**To:** John Tunstall, Norris & Tunstall  
**From:** Brian Chambers, Senior Planner; 910.342.2782  
**CC:** File;  
**Date:** 9/13/2021  
**Re:** Barclay Place Phase 2 TRC Rev 2

Project Name: Barclay Place Phase II

Department: Engineering – Plan Review Section

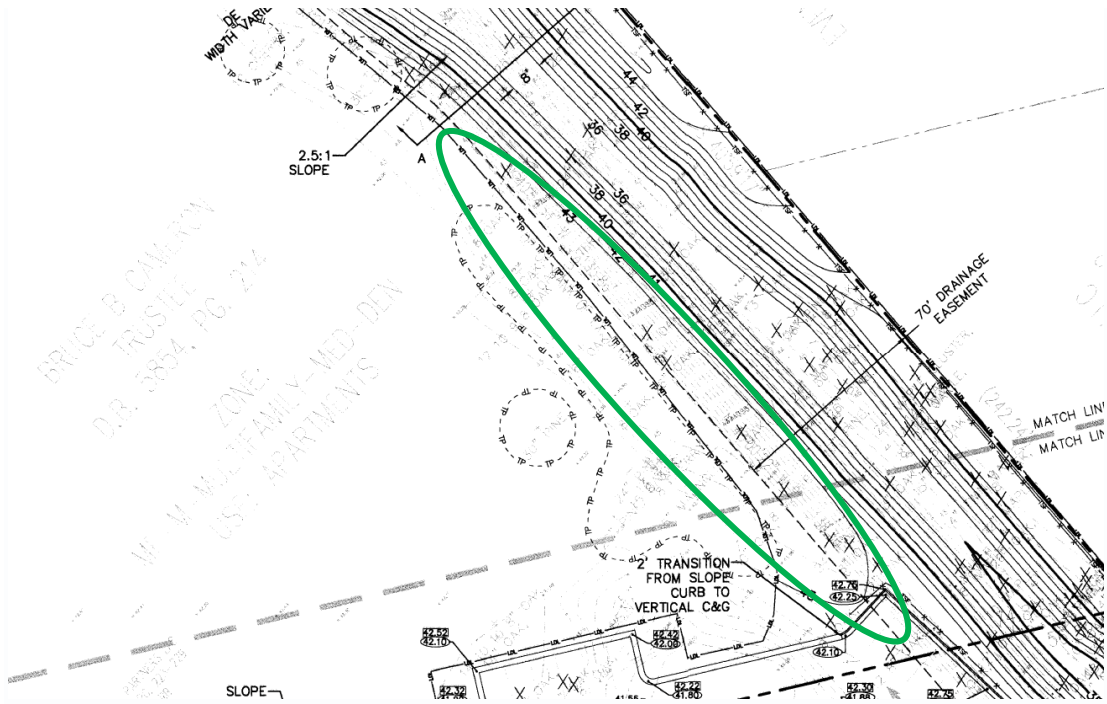
- Significant trees identified for removal on site inventory (I-1) do not match significant trees being removed on landscape plan (L1.0).
- Provide additional tree save along the Western bank of the ditch re-alignment. The 43' contour can be tightened up to reduce root zone impact. See below.
